# UNITED STATES PATENT AND TRADEMARK OFFICE

10/802,641

<b>Office Action Summary</b>	<b>Application No.</b>	<b>Applicant(s)</b>	
	10/802,641	LU ET AL.	
	<b>Examiner</b>	<b>Art Unit</b>	
	Justin Krause	3682

### **DETAILED ACTION**

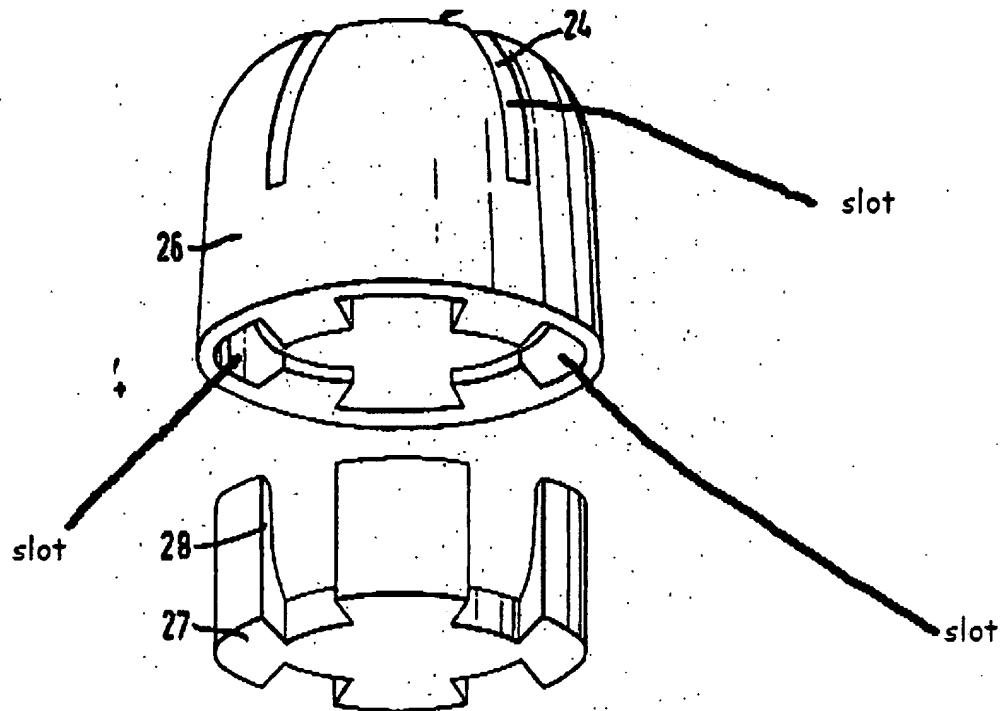
Farrant discloses a bearing with a stud member (13) with a stud head and a housing (11) with a central bore comprising:

An annular bearing body (26) that seats between the housing and the stud head, wherein the inner surface includes at least three radial slots (see fig below), two of said radial slots having a first radial depth which differs from a radial depth of each other radial slot.

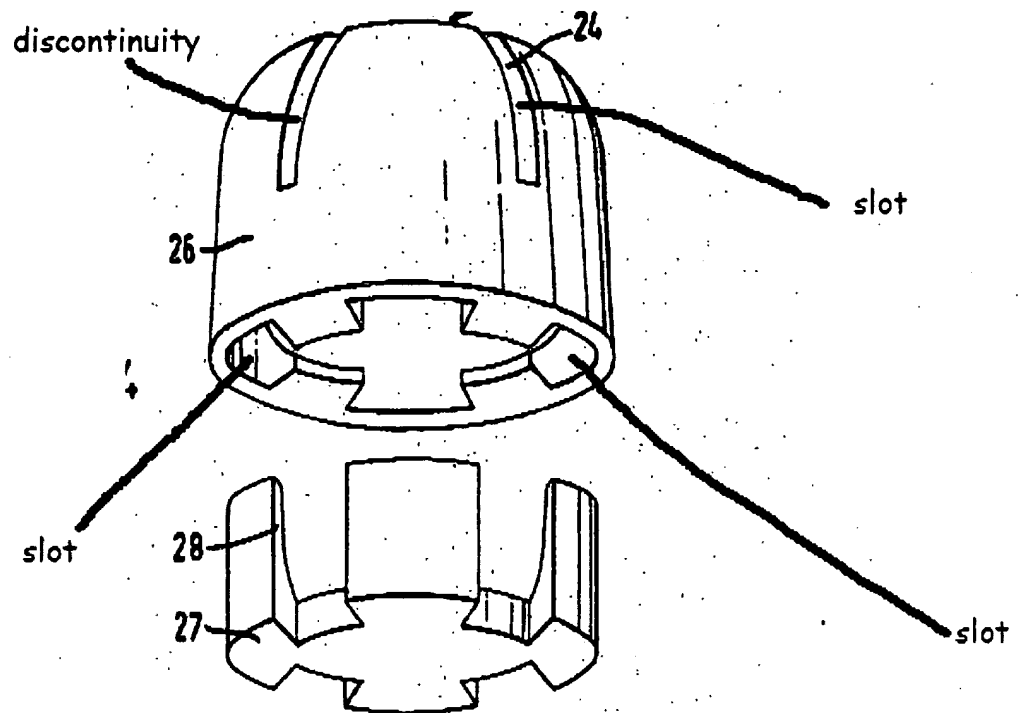
Regarding claim 2, the radial slots are symmetrically disposed about a vertical axis.

Regarding claim 3, the radial slot dimensions and placements are configured to minimize stresses.

Regarding claim 4, the radial slot dimensions and placements are configured to equalize stresses.

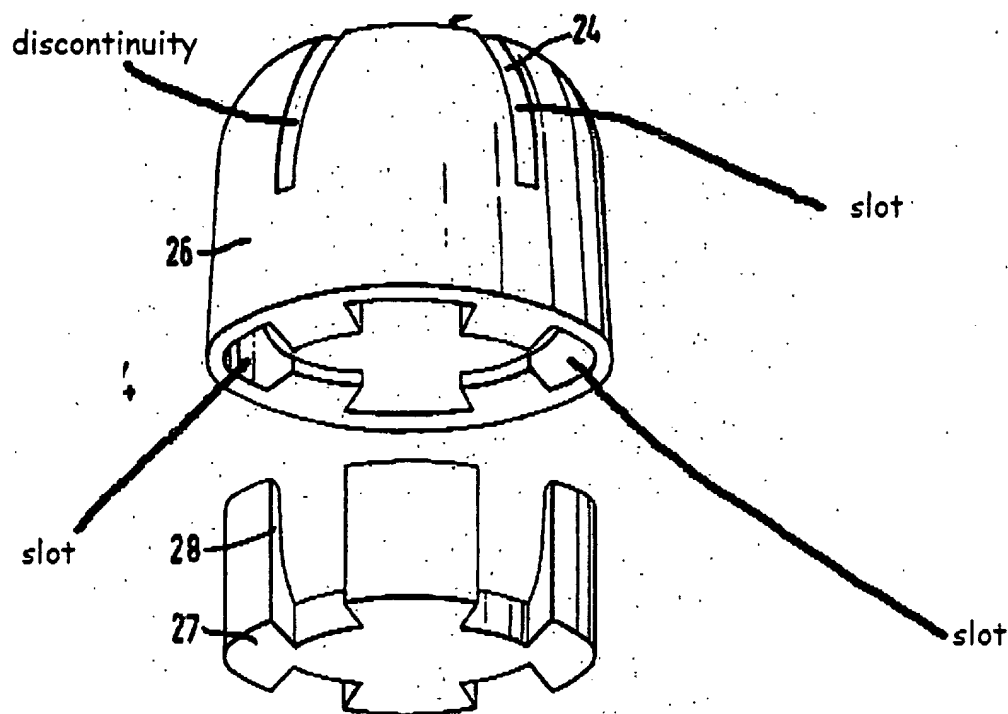
Regarding claim 5, the annular bearing body includes a discontinuity.

Regarding claim 6 and 7, an axial plane bisects the annular bearing into first and second mirror image portions.

Regarding claim 8, a radial depth associated with each radial slot in each of the first and second mirror image portions increases for each radial slot from a minimum radial depth in a first radial slot to a maximum radial depth in a last radial slot.
